Reply to Huw Clarke of Cuadrilla Resources Ltd [se-2015-134-SC9]

Mr Huw Clarke, Exploration Geologist of Cuadrilla Resources Ltd, has commented on my discussion paper (Smythe 2016) under the following headings, which all concern Cuadrilla's exploration in the UK:

Figure 1. A. Clarke et al. (2014, fig. 4) sample of east-west 3D seismic through the Preese Hall-1 well. B. Line drawing of reflectors with alternative fault positions noted. The semicircle on the lowermost blocked-out area is the upper half of the hypocentral location.

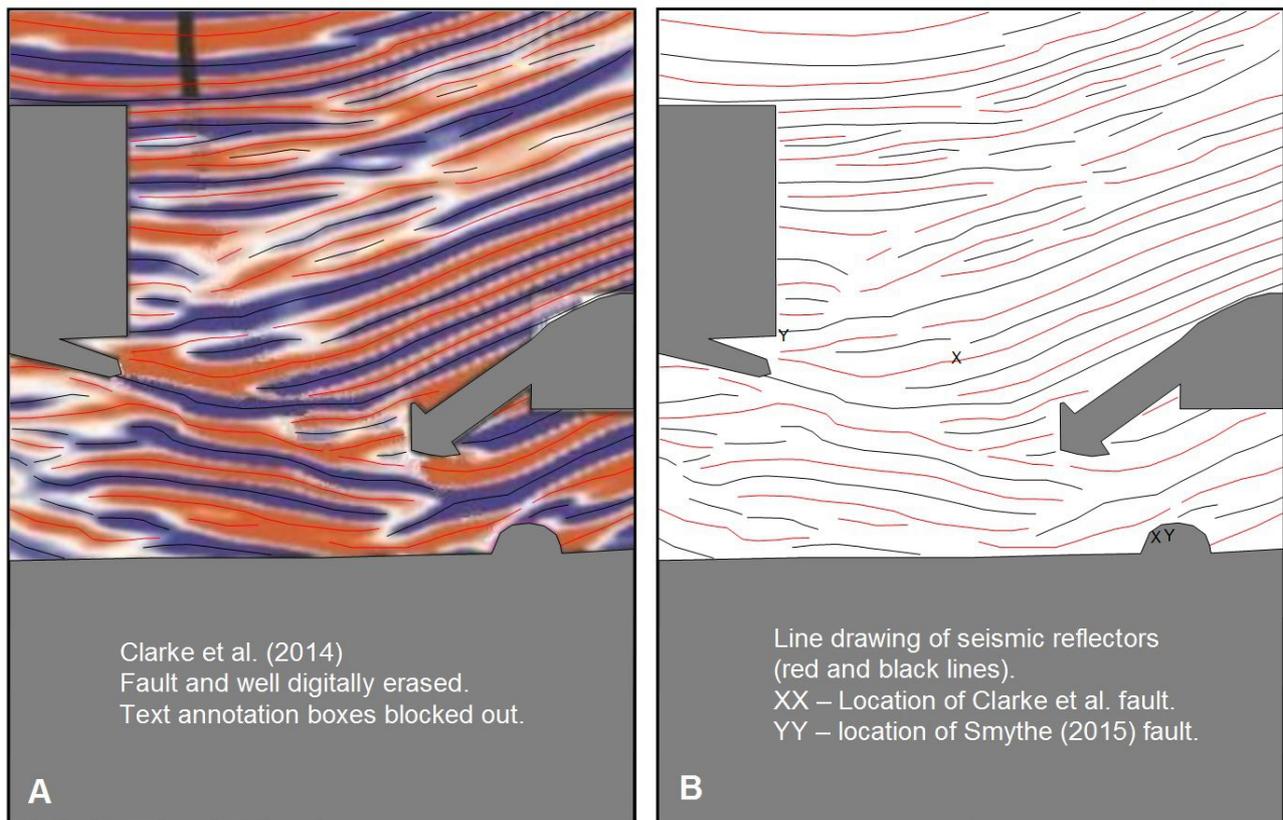
Mr Clarke disputes my reinterpretation of the earthquake-triggered fault, stating that I merely repositioned the fault on Clarke et al.'s figure 4, so as to expound my views on the hydrogeological risks of fracking in the Bowland Basin. This is not the case; I repositioned the fault in relation to the Clarke et al. hypocentral location, so as to honour the small sample of 3D seismic data that has been published. Figure 1 illustrates this as objectively as possible.

I have digitally erased both the wellbore and the Clarke et al. version of the fault in Figure 1A, then illustrated in Figure 1B my line drawing of the seismic reflectors (which can be discerned in Fig. 1A). XX and YY denote the interpreted positions of the fault according to Clarke et al. and to myself, respectively. I lettered the Figure 1B in a very small font so as not to draw the eye unnecessarily. Both fault versions originate at the hypocentral location. The Clarke et al. version cuts across seismic layering, which is unacceptable as an interpretation, whereas my version takes the most feasible path between the major groups of reflectors.

Mr Clarke notes firstly that the stratigraphic columns of PH-1 and two other neighbouring wells match very well in the Lower Bowland Shale, in the area of interest of PH-1 around 8500-8700 feet. But these logs are only precise enough to rule out a very large normal or reverse fault with a throw of (say) a hundred metres or more. Furthermore, the identification of a repeat or missing section as a means of fault identification in a vertical well does not apply to strike-slip faults. The fault in question is of this type.

Mr Clarke raises an objection to my fault placement, which is that if the well does indeed cut the fault, then why was the hypocentre not at the wellbore rather than 300 m away? I have already answered this in my discussion section 3.6, referring to the recent experiment by Guglielmi et al.

Figure 1. Detail of Balcombe-2z lithology log (modified from Smythe 2016 fig. 8B) showing transition of clay to micrite in the obliquely drilled well. Depths on the left are driller's depths in feet, as measured along the deviated wellbore.

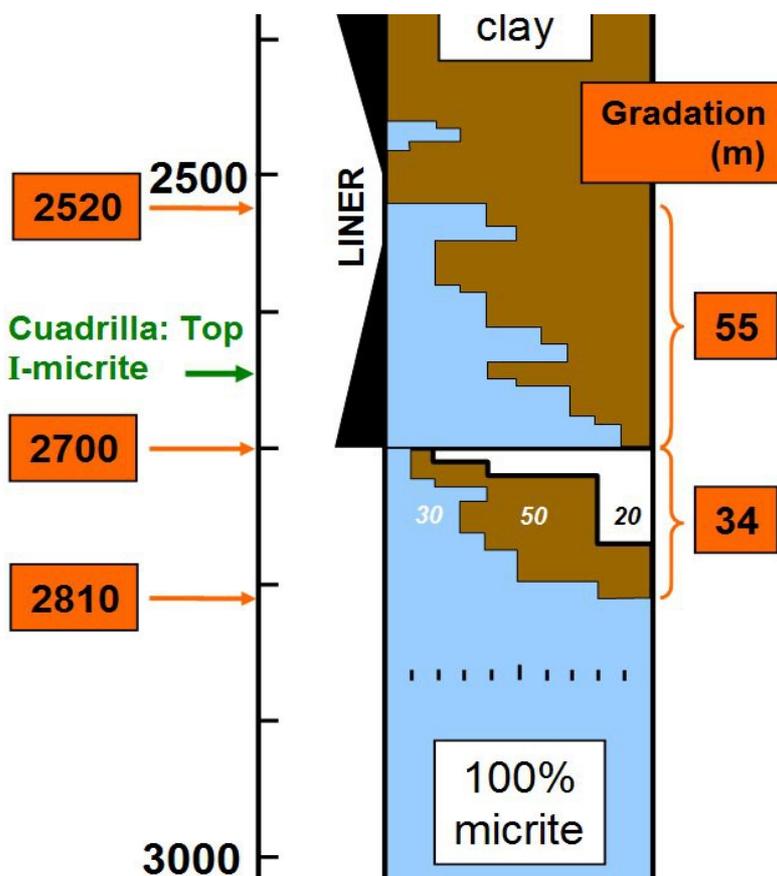
Mr Clarke discusses my Figure 8B, which was re-drawn from Cuadrilla Balcombe Ltd (2013), fig. A01. I stated in section 4.1:

"The lithology log shows a gradational change from 100% clay to 100% micrite over 55 m, but the gradation is repeated below 2700 ft, this time over about 34 m. It is possible, but unlikely, to explain the repetition by assuming that two separate logging runs were made and then poorly spliced together; but an alternative and more plausible explanation is that the wellbore went through a normal fault with a downthrow to the east (wellhead side)."

I reproduce a detail from my Fig. 8B, with a scale of 10% increments in lithology added.

I preferred my second explanation (a normal fault) because I could hardly imagine that two separate logging runs could have been spliced together so poorly. I was, of course, aware that the repeat section coincided with the casing shoe set at exactly 2700 ft, and as can be seen I took care to include the shoe and liner in my diagram.

I agree with Mr Clarke's explanation that the repeat section is due to a drilling artefact, and is not evidence of a normal fault. But several questions remain, so I return to my separate logging run explanation.

Mr Clarke accuses me of a poor understanding of drilling processes, and explains that the drilling out of the cement shoe resulted in the apparent repeat of the Kimmeridge Clay to I-micrite transition. But his explanation fails to fit the facts. If the same wellbore was being drilled for the second time through the shoe there would be a mixture of cement and micrite in the cuttings, with the former decreasing from 100% as the latter increased. The cement is implied by the white area in Fig. 1 (it is a light grey in the original diagram, as also shown by the litholog higher up in the vertical portion of the well, where the 9-5/8 inch shoe was drilled through). But where has the clay below 2700 ft come from? At 2750 ft the litholog shows (as marked in percent in Figure 1) 30% micrite, 50% clay and 20% cement.

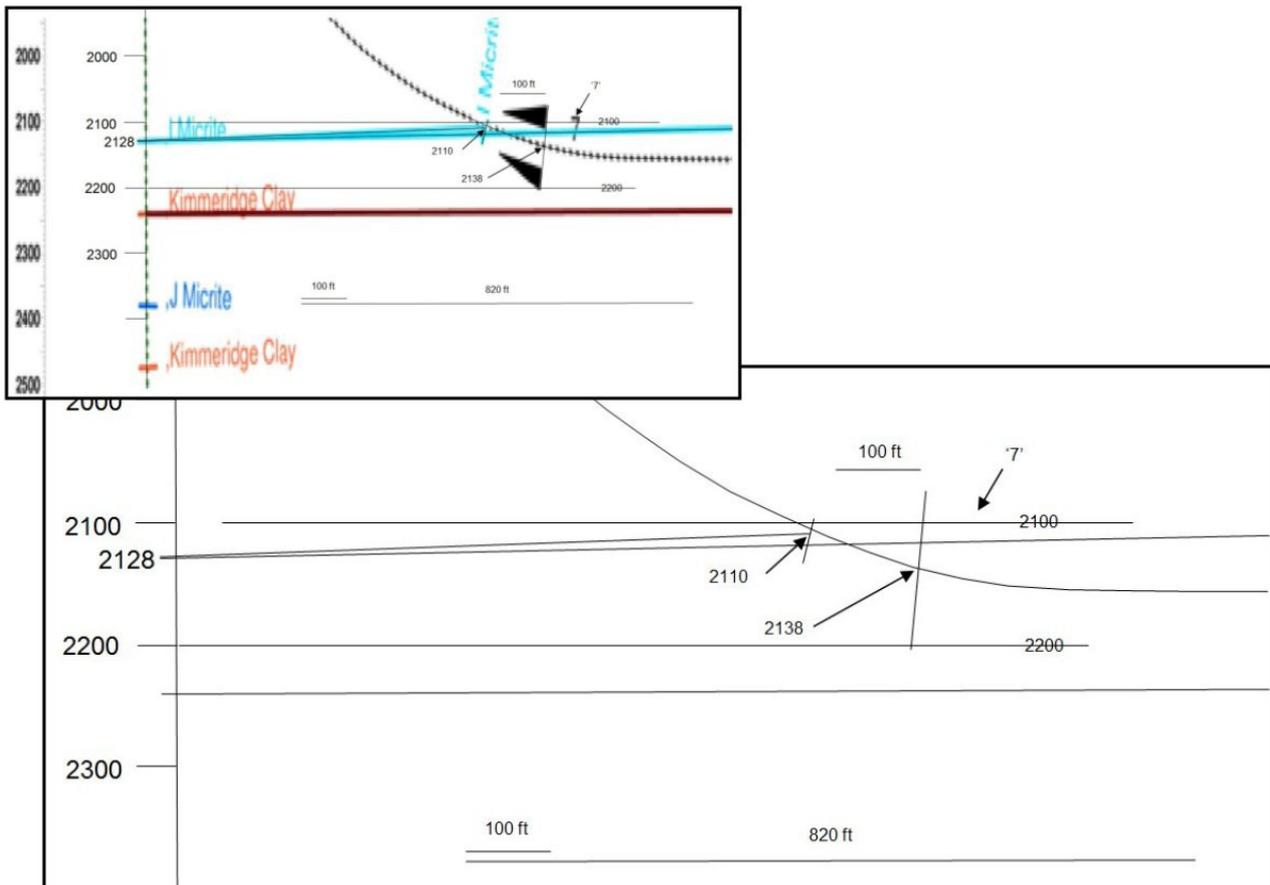
Let us examine the depth log of the deviated well, also taken from Cuadrilla's fig. A01, reproduced with annotation in Figure 2. Here we see the cross-section accompanying the vertical section of Fig. 1. Referring to the lower part; the top I-micrite is taken as being at 2128 ft, as at Balcombe-1 (depths here are true vertical depth sub-sea). But there are two light blue lines indicating this

horizon running to the right. One intersects the wellbore at 2110 ft, and the other at 2138 ft., and separated by a horizontal distance of about 127 ft. The 2110 ft mark at the end of the upper blue line is the top micrite, which dips slightly to the left. The shoe, whose base is at 2138 ft, some 28 ft lower, was set where the proportion of micrite to clay was 90% (Fig. 1), and presumably increasing to 100% the farther (i.e. deeper) the wellbore was drilled. So the return to a high proportion of clay (40% micrite, 60% clay, discounting the cement proportion) is inexplicable.

- Two drilling runs, of which the second was allegedly drilled straight through the shoe,
- Two conflicting blue lines indicating the top micrite in the cross-section of Figure 2, and
- An apparent repeat entry through the transition zone of clay to micrite (as measured from

It is possible that the two conflicting blue lines shown in Figure 1, both purporting to represent the top of the micrite, could be due to the second drilling run being sidetracked out of the first, to land at a slightly different angle in the micrite. But this is speculation, without enough facts to go on.

If Mr Clarke could provide a little more detail of the drilling activities, including, for example, the gamma ray logs over the interval in question (which could prove that the wellbore remained in 90-100% micrite from the shoe onwards), it would go a long way to clearing up these discrepancies. In the absence of such evidence I rest with my two alternative explanations of (a) a fault, or (b) poorly spliced logs, but shall now favour the latter.
